Subject: SUNROOF OPENS BY ITSELF	Bulletin No: 09-040/16
	Last Issued: 06/24/2016

APPLICABLE MODEL(S)/VINS

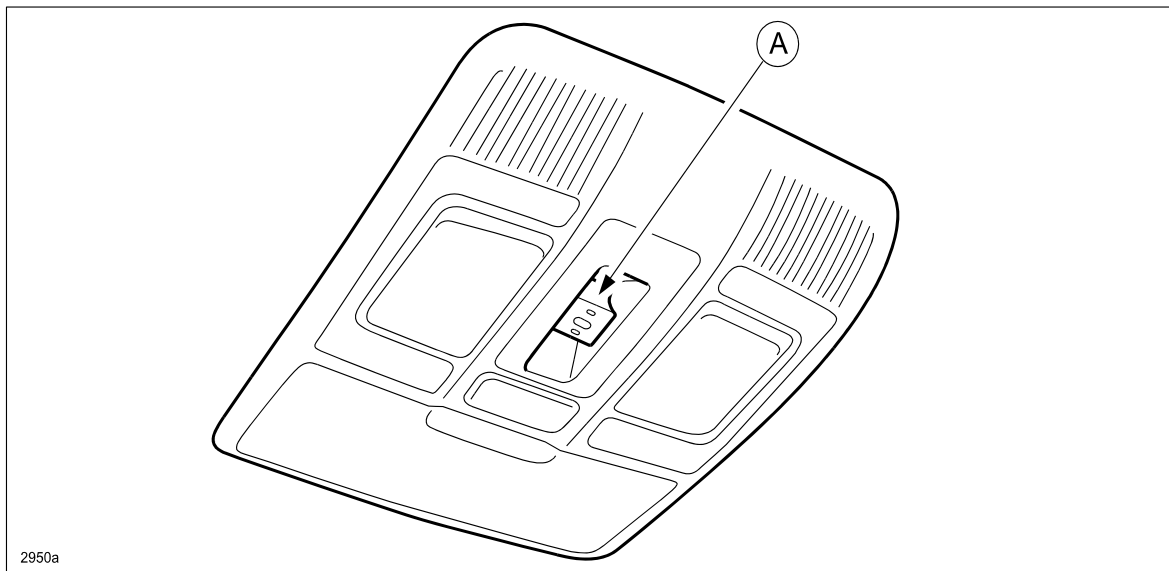
Some customers may complain that in extreme cold weather conditions, the sunroof may suddenly open by itself when the heater is on. This concern may be due to a short in the sunroof switch (A) caused from condensation generated between the roof panel and the seal.

To eliminate this concern in the future, a protective film has been installed to the switch and a pad installed to the harness.

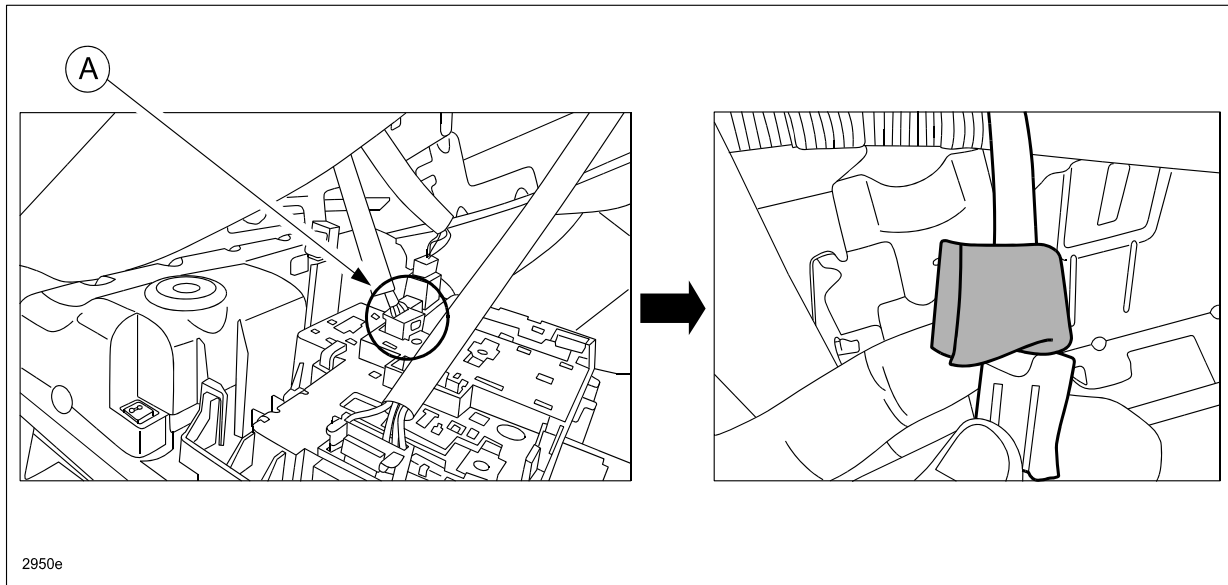
1. Remove the front map light (with sunroof switch) according to the instructions on MS3 (MAP LIGHT REMOVAL/INSTALLATION).
2. Cut a 20 mm x 50 mm piece from the urethane pad.
NOTE: One (1) pad can repair ten (10) vehicles.
3. Attach the 20 mm x 50 mm piece of urethane pad around the sunroof connector harness (A), as shown below.

NOTE: The sunroof connector is located in the center of the map light.
